CITY OF ALBUQUERO

Re: **Gyro Shack Commissary** 3210 Candelaria Rd. NE **Traffic Circulation Layout** Architect's Stamp 07-01-22 (H16-D111)

Based upon the information provided in your submittal received 07-07-22, the above referenced plan cannot be approved for Building Permit until the following comments are addressed:

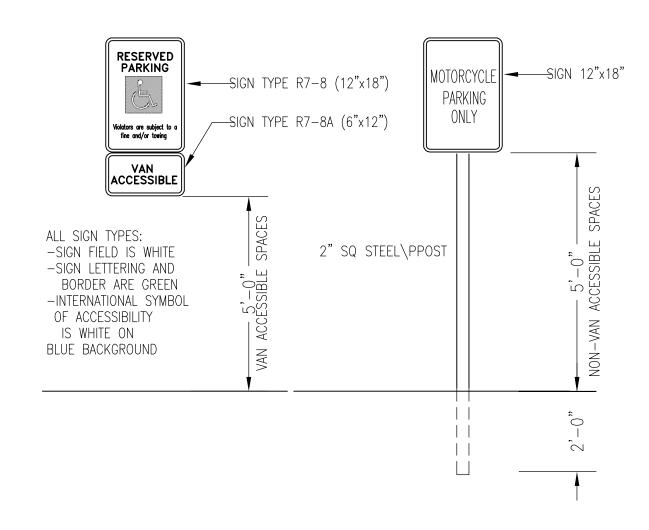
1. Identify the right of way width, medians, curb cuts, and street widths on Candelaria Rd.

Curn Return design is recommended as a driveway access off Candelaria Rd. please

- 2. address this concern. 3.
 - 4. ADA curb ramps must be updated to current standards and have truncated domes installed.
 - 5. All bicycle racks shall be designed according to the following guidelines:

ADA Van parking stall width should be min. 8.5 ft.

- a. The rack shall be a minimum 30 inches tall and 18 inches wide.
- b. The bicycle frame shall be supported horizontally at two or more places. Comb/toaster racks are not allowed.

- c. The rack shall be designed to support the bicycle in an upright position. See the IDO for additional information.
- d. The rack allows varying bicycle frame sizes and styles to be attached.

- e. The user is not required to lift the bicycle onto the bicycle rack.
- Each bicycle parking space is accessible without moving another bicycle.
- 6. Bicycle racks shall be sturdy and anchored to a concrete pad.

- 7. A 1-foot clear zone around the bicycle parking stall shall be provided.
- 8. Bicycle parking spaces shall be at least 6 feet long and 2 feet wide.
- 9. A 5 ft. keyway is required for dead-end parking aisles.

- Refuse vehicle maneuvering shall be contained on-site. The refuse vehicle shall not back into the public right of way.; provide a copy of refuse approval.

- Please provide a sight distance exhibit

- 12. Show the clear Intersection sight triangle and add the following note to the plan: "Landscaping and signage will not interfere with clear sight requirements. Therefore, signs, walls, trees, and shrubbery between 3 and 8 feet tall (as measured from the gutter pan) will not be acceptable in the clear sight triangle. Please see attached Intersection sight triangle.
